CPSES-200101541
Log # TXX-01118
File # 00236

SUBJECT: COMANCHE PEAK STEAM ELECTRIC STATION (CPSES)
DOCKET NOS. 50-445 AND 50-446
SUPPLEMENT THREE TO LICENSE AMENDMENT REQUEST
(LAR) 00-05: REVISION TO TECHNICAL SPECIFICATION SPENT
FUEL ASSEMBLY STORAGE RACKS AND FUEL STORAGE
CAPACITY
(TAC NOS. MB0207 and MB0208)

ATTACHMENT 2 to TXX-01118
RETYPED TECHNICAL SPECIFICATION PAGES

Comanche Peak High Density Spent Fuel Rack Criticality Analysis Using Soluble Boron Credit And No Outer Wrapper Plates

FIGURE 3.7.17-1
Fuel Assembly Burnup vs. U-235 Enrichments vs. Decay Time Limits
For a 4 out of 4 Storage Configuration in Region II Racks

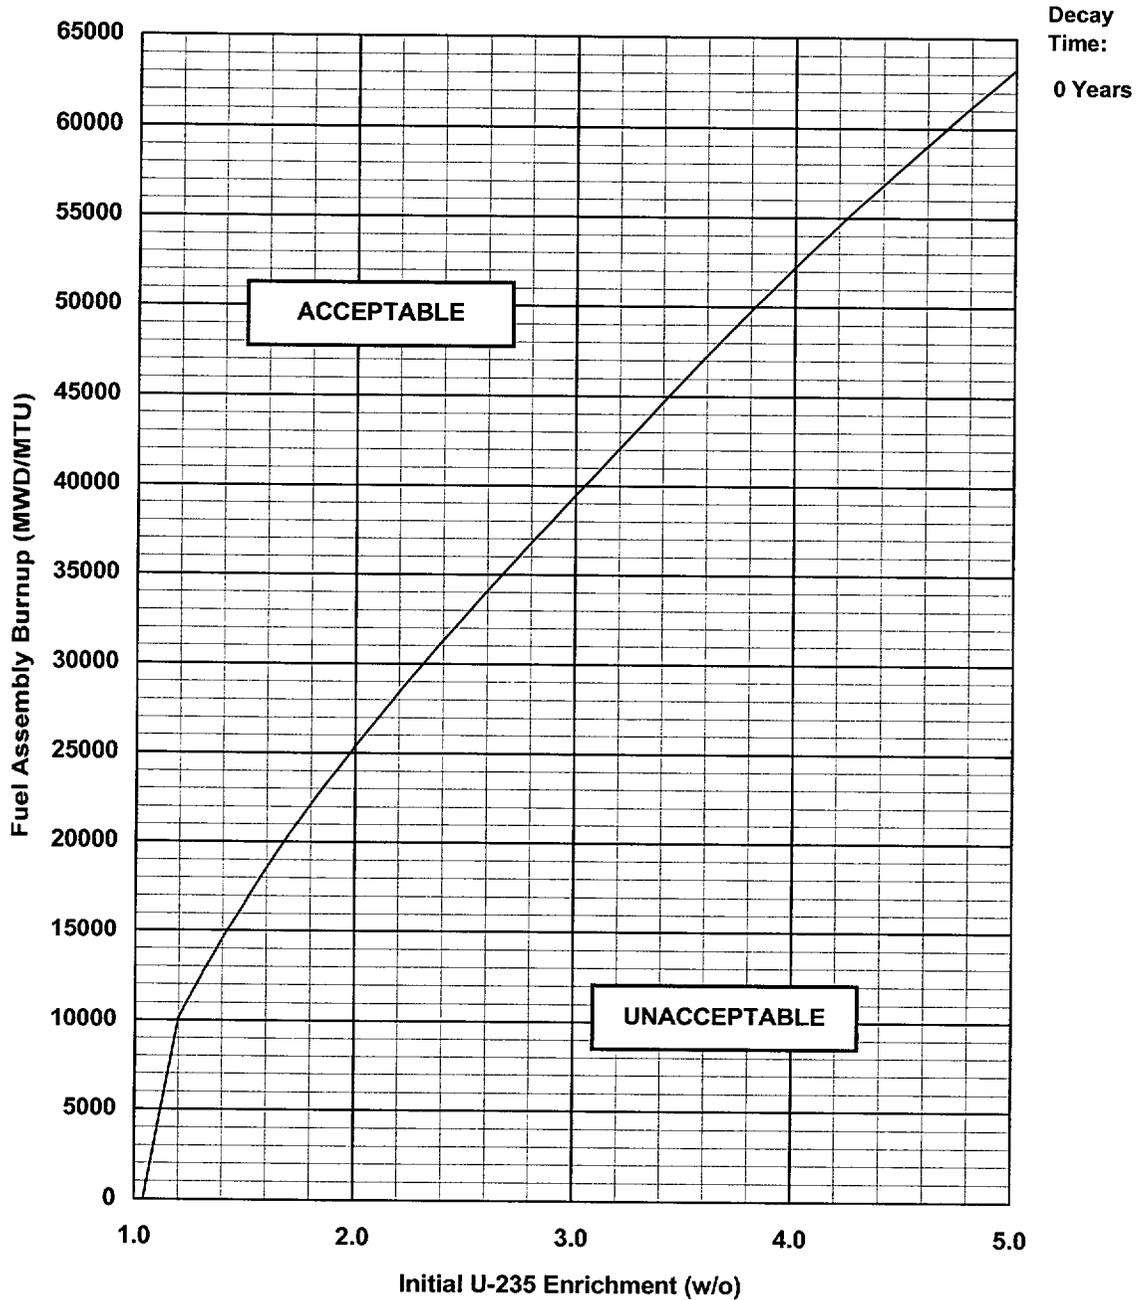
Attachment 1 is the required affidavit. Attachment 2 provides new Technical Specification pages to reflect the updated criticality analysis. TXU Electric's assessment concerning the no significant hazards consideration determination was not revised as the original assessment remains valid (see Attachment 2 to Reference 1).

**Figure 3. Comanche Peak High Density All Cell Configuration
Burnup Credit Requirements**

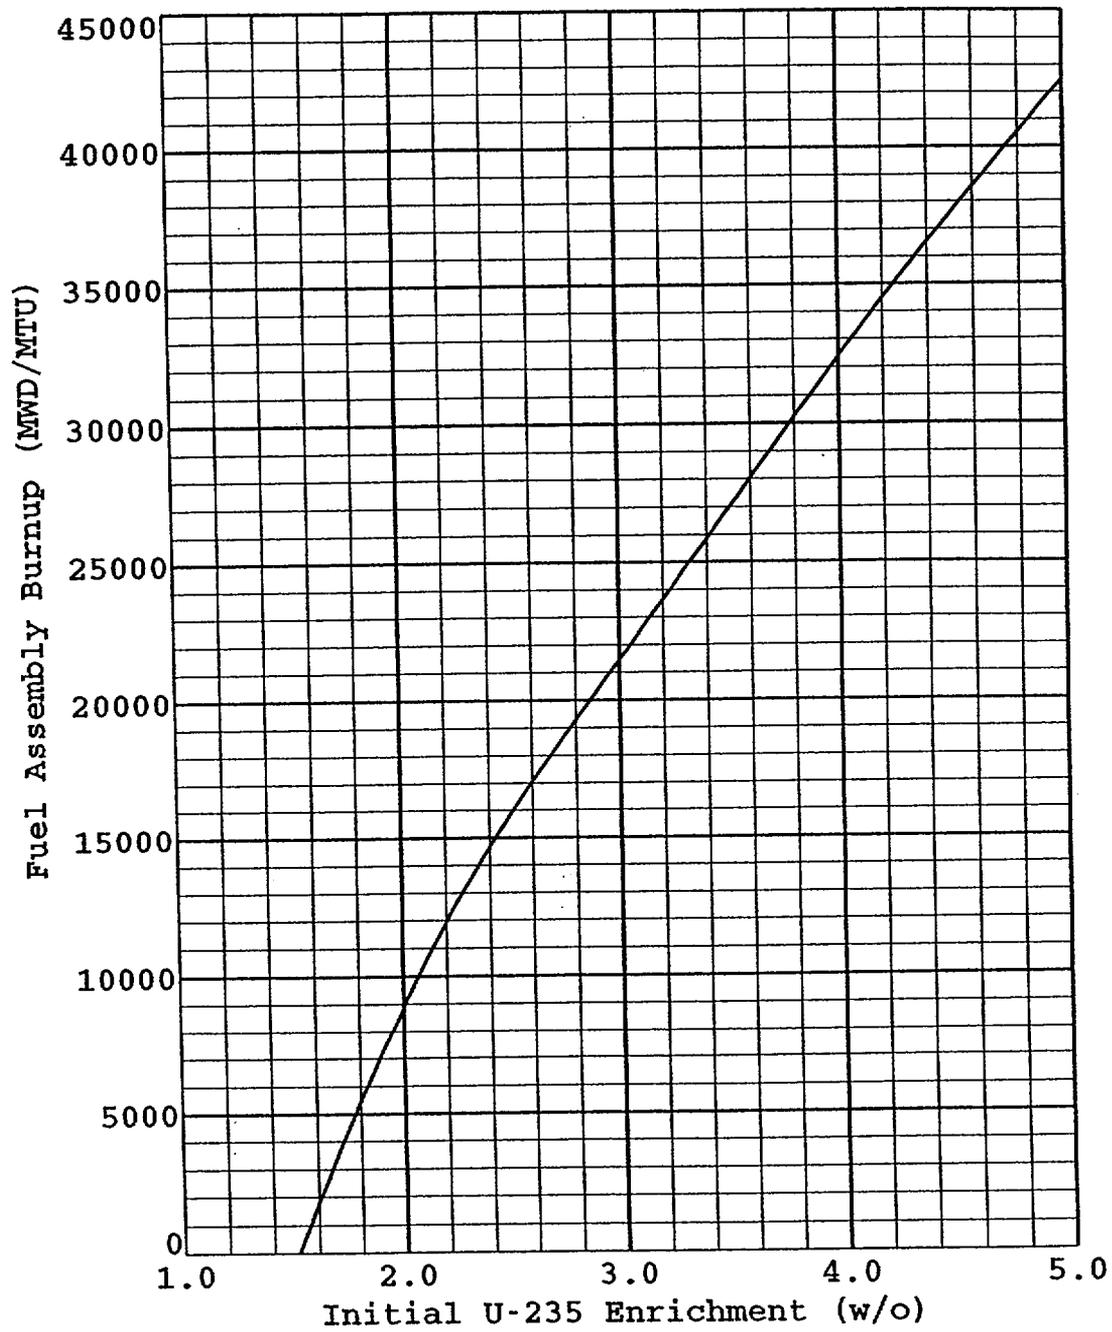
For the 4-out-of-4 configuration, the credits for the overall conservatism identified minus the effect of revised axial burnup bias result in net reactivity penalty of -0.00206 ΔK . To offset this net reactivity penalty, the burnup requirements specified in Table 6 and the corresponding Figure 3 have been conservatively increased. The adjusted burnup requirements are shown in Table 6 and corresponding Figure 3 of this report.

** In order to offset this net reactivity penalty, the burnup requirements specified in Table 6 and corresponding Figure 3 were increased to provide an additional reactivity credit of .00500 delta-K at 60,000 MWD/MTU. The required burnup values were increased linearly from 0 at 17,000 MWD/MTU through 770 MWD/MTU at 60,000 MWD/MTU. With consideration of this additional .00500 delta-K credit, the net balance then becomes +.00294 delta-K.

Figure 4. Comanche Peak High Density 3-out-of-4 Checkerboard Configuration Burnup Credit Requirements

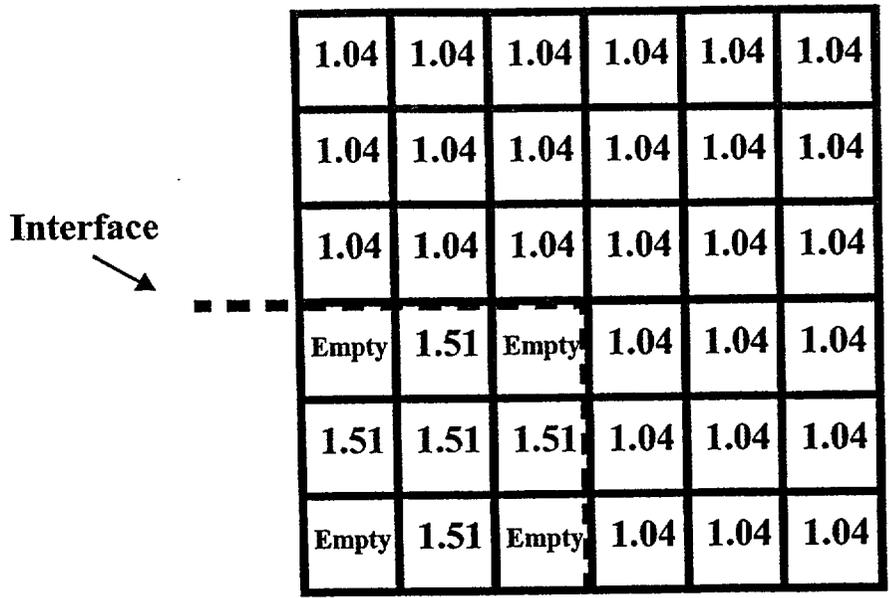
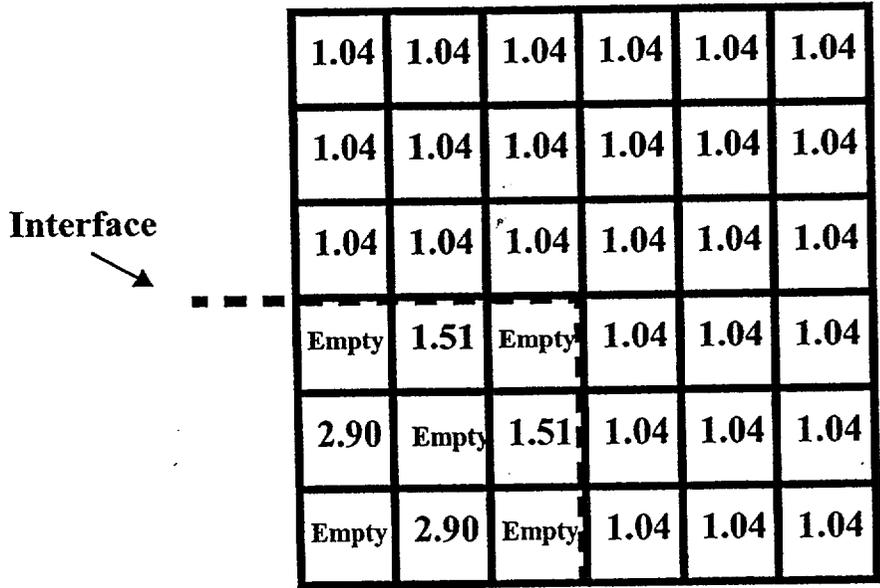
For the 3-out-of-4 configuration, the credits for the overall conservatism identified minus the effect of revised axial burnup bias result in net reactivity penalty of -0.00041 ΔK . To offset this net reactivity penalty, the burnup requirements specified in Table 7 and the corresponding Figure 4 have been conservatively increased. The adjusted burnup requirements are shown in Table 7 and corresponding Figure 4 of this report.

* In order to offset this net reactivity penalty, the burnup requirements specified in Table 7 and corresponding Figure 4 were increased to provide an additional reactivity credit of .00200 delta-K at 42,156 MWD/MTU. The required burnup values were increased linearly from 0 at 17,000 MWD/MTU through 320 MWD/MTU at 42,156 MWD/MTU. With consideration of this additional .00200 delta-K credit, the net balance then becomes +.00159 delta-K.
